SUBJECT: DEMONSTRATION / DELIVERY HOLD - Safety 15S26
Certain 2015 Model Year Taurus and MKS and 2016 Model Year Explorer Vehicles
Fuel Tank Attachment Bolt Torque

DEMONSTRATION / DELIVERY HOLD Safety Recall 15S26
Certain 2015 Model Year Taurus and MKS and 2016 Model Year Explorer Vehicles
Fuel Tank Attachment Bolt Torque

FIGURE 1

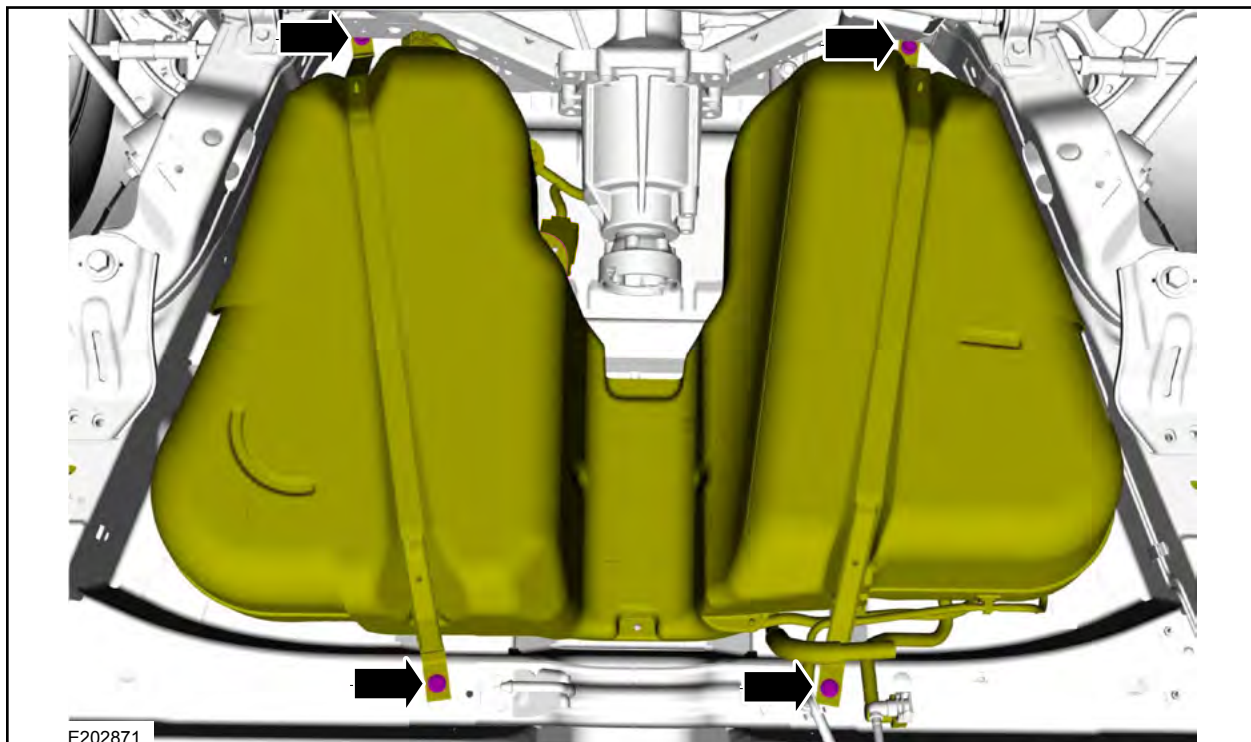
3. Loosen each of the four fuel tank bolts one full turn. See Figure 1.

NOTE: Explorer AWD shown, other vehicles similar.

4. Tighten and then torque the four fuel tank bolts to 26 lb.ft (35 Nm).

- For Explorer vehicles, use an extension and swivel socket to torque all four bolts. Do not allow the extension and socket to exceed 15° of swivel angle while torquing the bolts to specification.
- For Taurus/MKS vehicles, use an extension and swivel socket to torque the two front bolts. Do not allow the extension and socket to exceed 15° of swivel angle while torquing the bolts to specification.
- For Taurus/MKS vehicles, the two rear bolts must be torqued using a suitable Adjustable Torque Wrench Adapter. Refer to Torque Wrench Adapter Formulas within the WSM to calculate proper torque as required. See Figure 2.
